**Re: Seniors Housing Development at 35-39 West St, Lurnea**

## Attachment 1: Comments on Seniors Housing Development at 35-39 West St, Lurnea

## Appendix G – Response to Liverpool City Council Recommended Conditions

Figure 1: Recommended concrete path

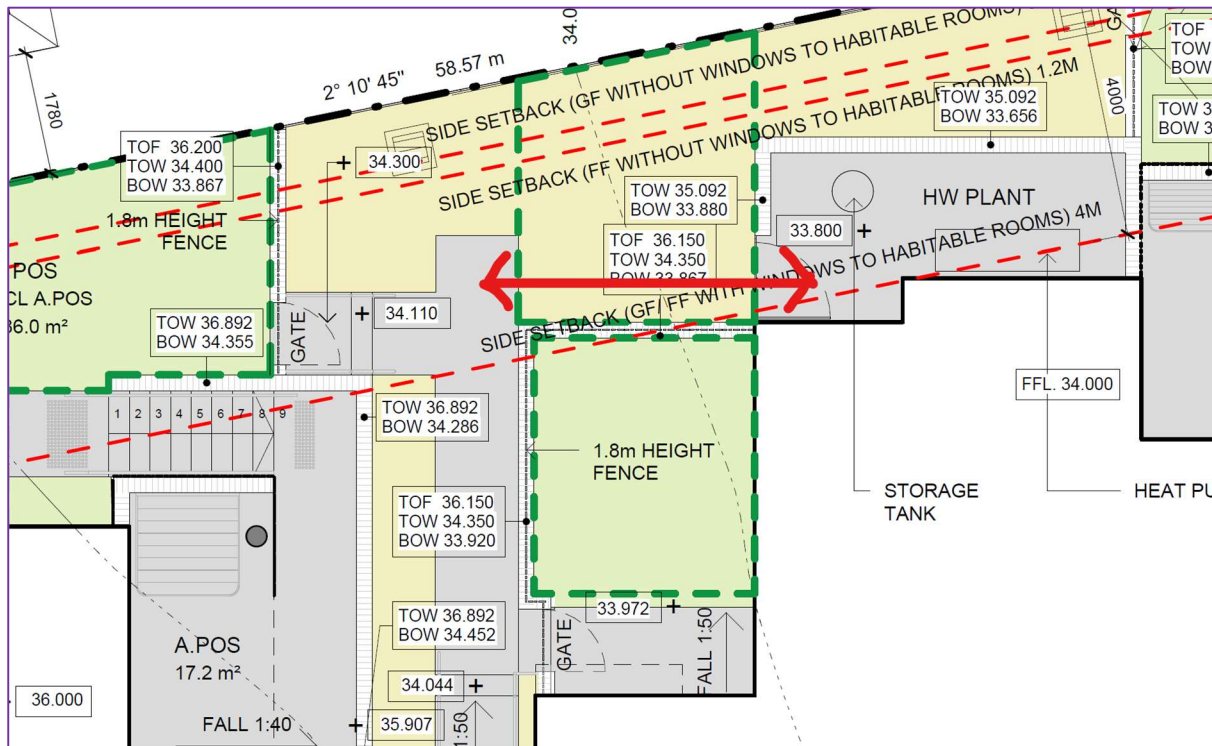
The proposed development provides additional landscaping and deep soil areas than required by the SEPP. However, it is noted that there is no footpath connection from the back access to the service area. For maintenance purposes, this should be concrete paving (refer to Figure 1 below). This change will decrease the rear deep soil zone.

Figure 2: Recommended Communal Open Space

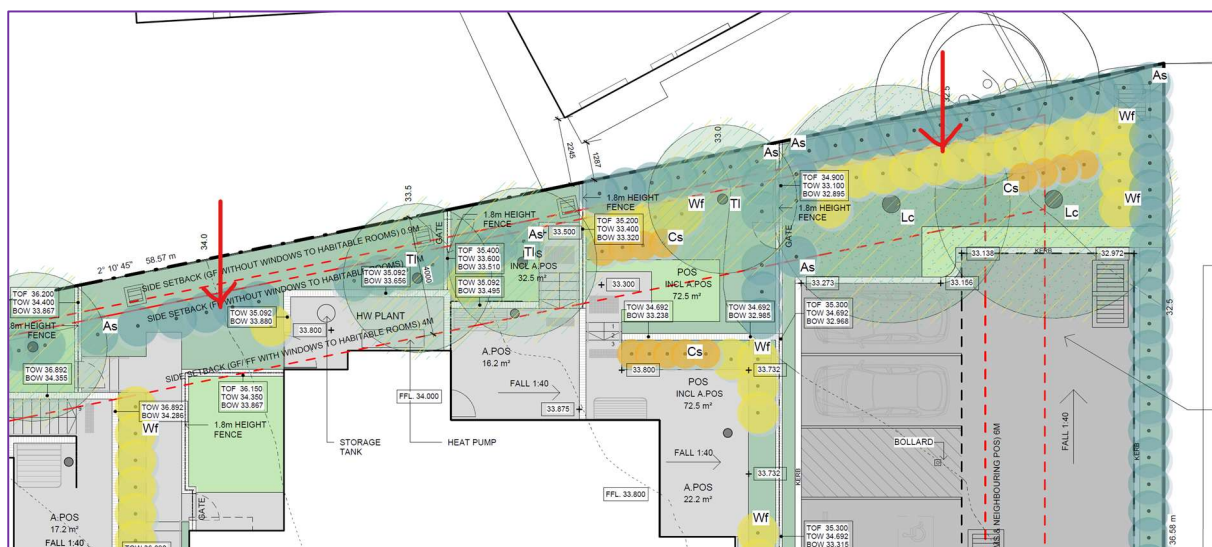
Additionally, the NSW Seniors Housing Design Guide, Chapter 6.12 Building Communities, contains the objectives 6.12.2 and 6.12.3 encourages developments to provide safe places for residents to come together. No communal areas have been provided within the proposed development, and there is an opportunity to include places to gather in the rear landscape areas, as noted in Figure 2 below. These areas are to be accessible.
